Great Planes Pluma ARF Technical Notice

Aileron Link Rods - (4) Required

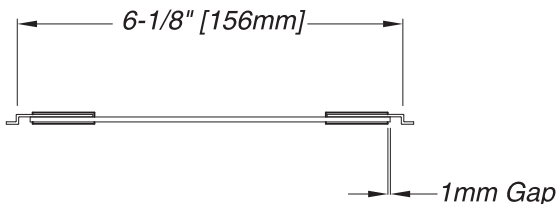
On page 7, step number 1 should read:

1. Locate four 1 x 145mm carbon pushrods, eight 1 x 30mm Z-bends, and eight 25mm pieces of heat shrink tubing. Assemble four aileron link rods as shown in the sketch above so that they measure **6-1/8" [156mm]** from Z-bend center to Z-bend center. See the **Expert Tip** below on how to assemble pushrods.
